## **APPENDIX K: OHIO EPA COMMENTS**

**Subject: Response to Ohio EPA Comments on the "Draft Facility-wide Groundwater Monitoring Annual Report for 2018"**

Subject: Ravenna Army Ammunition Plant (RVAAP) Restoration Program, Portage/Trumbull Counties, RVAAP-66 Facility-Wide Groundwater, Responses to Comments on the Draft Facility-wide Groundwater Monitoring Annual Report for 2018 (Work Activity No. 267-000-859-036)

**Subject: Ohio EPA Comments on the "Draft Facility-Wide Groundwater Monitoring Annual Report for 2018," Dated February 14, 2019**

Figure 3-3. Geologic Bedrock Map and Stratigraphic Description of Units at Camp James A. Garfield

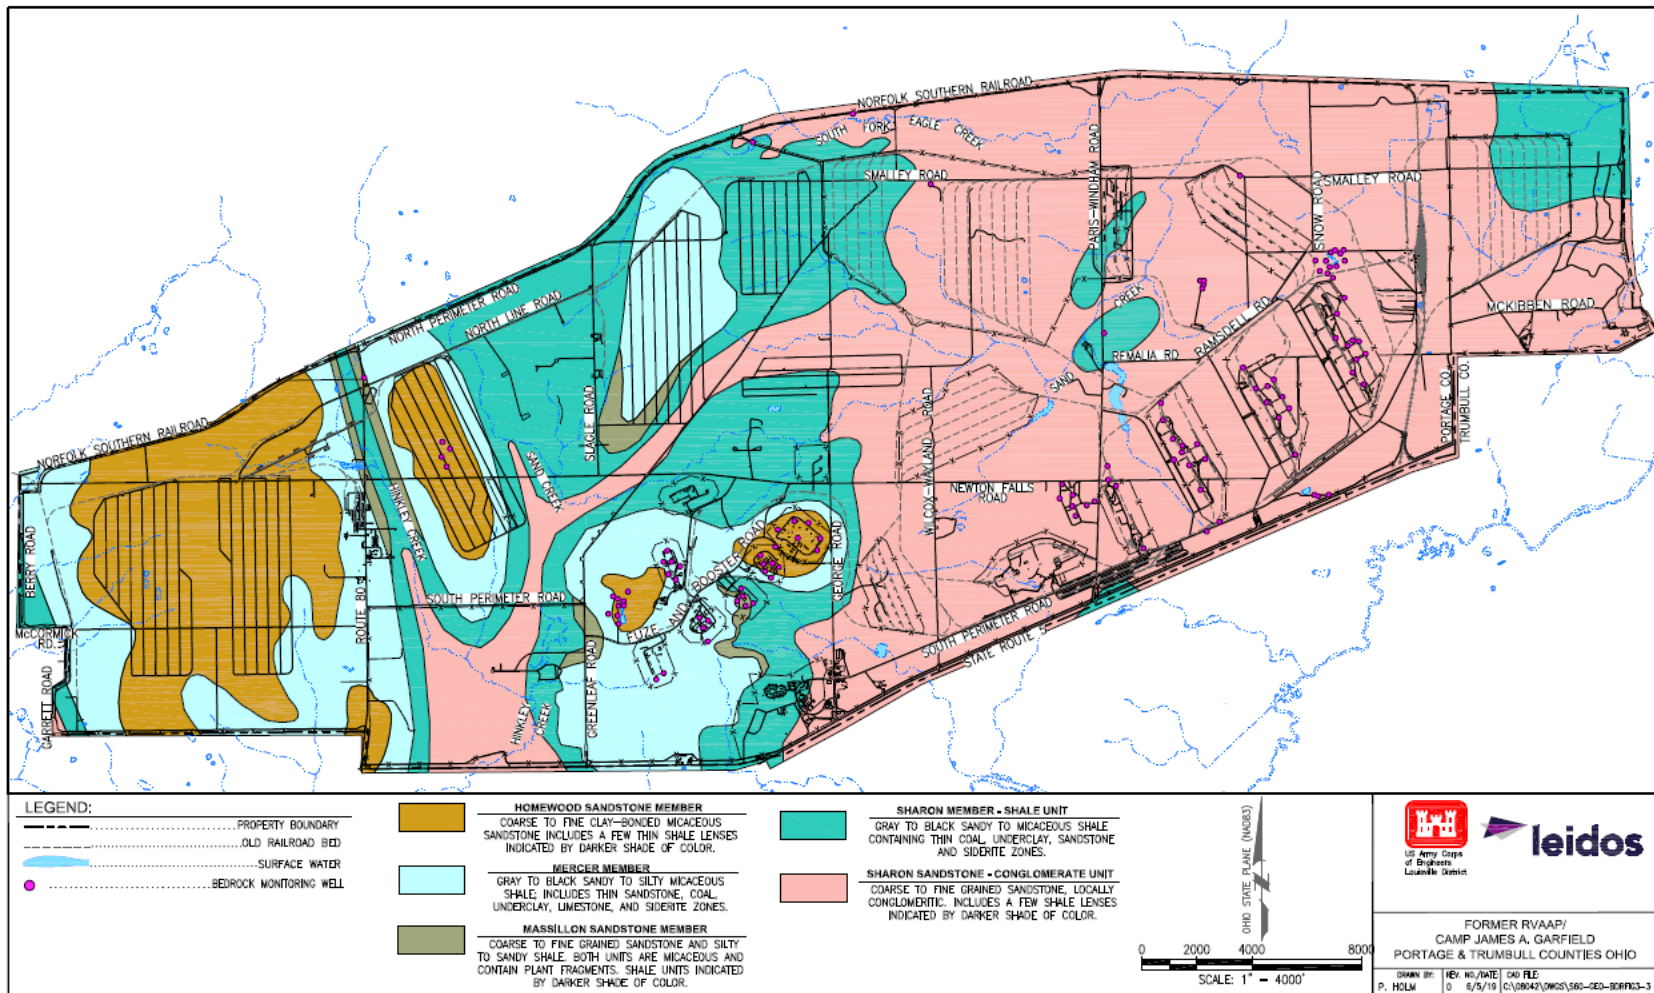
Figure 3-3 in the report appears to depict inaccurate bedrock geology. Although Figure 3.3 is unattributed to a specific source, it appears to be copied from a faulty 2004 Portage Environmental/USACE map that misinterpreted the bedrock geology beneath the facility from the original United States Geological Survey (USGS) and Ohio Department of Natural Resources (ODNR) source documents (e.g., Geology and Ground Water Resources of Portage County, Ohio [Winslow and White, 1966] and Reconnaissance Bedrock Geology of Newton Falls, Ohio Quadrangle [Slucher and Larsen, 1996]). One source of error is likely that the colors used to map the Sharon Member and the Berea Member on the 1966 Winslow and White map are similar. On several previous occasions, Ohio EPA has commented on similar copies of the aforementioned inaccurate map that has appeared in submissions to the Agency. The bedrock geology shown on Figure 3-3 is inconsistent with the geology shown on geologic cross-sections shown in Figures 3-5 and 3-6 of the submitted report, published USGS, ODNR, and other maps and scholarly/professional literature and what is known of site bedrock geology from facility boring and well logs.

First, the key for the rock column on Figure 3-3 is presented as being out of sequence. It incorrectly suggests that the Devonian aged Berea Sandstone (Note: before the late 1980s the Berea was assigned a Mississippian age) is the youngest bedrock beneath the site and that the Mississippian aged Cuyahoga Group occurs between the Pennsylvanian aged Massillon and Homewood Sandstones. By convention, explanation keys on geologic maps present the units from youngest to oldest. The explanation key on Figure 3-3 is confusing because it is out of sequence and does not convey an understanding of the site geology.

Secondly, Figure 3-3 incorrectly shows Berea Sandstone as the uppermost bedrock in three areas along Paris-Windom Road. The geologic map in Winslow and White (1966), shows the uppermost bedrock in those three aforementioned areas as Pennsylvanian aged Sharon Shale.

Thirdly, Figure 3-3 shows the uppermost bedrock in the northeast corner of the facility is mapped as Mississippian aged Cuyahoga Group. However, ODNR's 1996 map (Slucher and Larson) shows the aforementioned area mapped as Pennsylvanian aged Pottsville Group (Sharon). Slucher and Larson (1996) show a small area of Camp Garfield South of the East Group 7 Igloos in Trumbull County where the Devonian aged Berea and Mississippian aged Cuyahoga Group are the uppermost bedrock units. Figure 3-3 does not show the Devonian Berea and Mississippian Cuyahoga Group mapped as such. Currently, there are no FWGWMP/RI wells located in northeast portion of RVAAP, currently Camp James A. Garfield, in Trumbull County to provide any additional site-specific bedrock boring data that would refute the 1996 ODNR mapping.

**Comment 1 Action Item:** Ohio EPA recommends utilizing the more accurate geologic map provided in the approved RI Work Plan (Figure 1-3 from the December 2016 RI Work Plan, as approved by Ohio EPA in March 2017). If it is not used, Figure 3-3 needs to be explained or revised.

Figure 3-3 in the report appears to depict inaccurate bedrock geology. Although Figure 3.3 is unattributed to a specific source, it appears to be copied from a faulty 2004 Portage Environmental/USACE map that misinterpreted the bedrock geology beneath the facility from the original United States Geological Survey (USGS) and Ohio Department of Natural Resources (ODNR) source documents (e.g., Geology and Ground Water Resources of Portage County, Ohio [Winslow and White, 1966] and Reconnaissance Bedrock Geology of Newton Falls, Ohio Quadrangle [Slucher and Larsen, 1996]). One source of error is likely that the colors used to map the Sharon Member and the Berea Member on the 1966 Winslow and White map are similar. On several previous occasions, Ohio EPA has commented on similar copies of the aforementioned inaccurate map that has appeared in submissions to the Agency. The bedrock geology shown on Figure 3-3 is inconsistent with the geology shown on geologic cross-sections shown in Figures 3-5 and 3-6 of the submitted report, published USGS, ODNR, and other maps and scholarly/professional literature and what is known of site bedrock geology from facility boring and well logs.

First, the key for the rock column on Figure 3-3 is presented as being out of sequence. It incorrectly suggests that the Devonian aged Berea Sandstone (Note: before the late 1980s the Berea was assigned a Mississippian age) is the youngest bedrock beneath the site and that the Mississippian aged Cuyahoga Group occurs between the Pennsylvanian aged Massillon and Homewood Sandstones. By convention, explanation keys on geologic maps present the units from youngest to oldest. The explanation key on Figure 3-3 is confusing because it is out of sequence and does not convey an understanding of the site geology.

Secondly, Figure 3-3 incorrectly shows Berea Sandstone as the uppermost bedrock in three areas along Paris-Windom Road. The geologic map in Winslow and White (1966), shows the uppermost bedrock in those three aforementioned areas as Pennsylvanian aged Sharon Shale.

Thirdly, Figure 3-3 shows the uppermost bedrock in the northeast corner of the facility is mapped as Mississippian aged Cuyahoga Group. However, ODNR's 1996 map (Slucher and Larson) shows the aforementioned area mapped as Pennsylvanian aged Pottsville Group (Sharon). Slucher and Larson (1996) show a small area of Camp Garfield South of the East Group 7 Igloos in Trumbull County where the Devonian aged Berea and Mississippian aged Cuyahoga Group are the uppermost bedrock units. Figure 3-3 does not show the Devonian Berea and Mississippian Cuyahoga Group mapped as such. Currently, there are no

**Comment 1 Action Item:** Ohio EPA recommends utilizing the more accurate geologic map provided in the approved RI Work Plan (Figure 1-3 from the December 2016 RI Work Plan, as approved by Ohio EPA in March 2017). If it is not used, Figure 3-3 needs to be explained or revised.

**Army Response:** Agree. Attached is a revised Figure 3-3 which reflects what was in Figure 1-3 of the RI Work Plan. Please note that the color scheme has been revised to closely mirror what is in the cross sections in Figures 3-4 and 3-5, and the order in the legend has been revised from youngest to oldest.

Reference Ohio EPA Comment 1, revised Figure 3-3
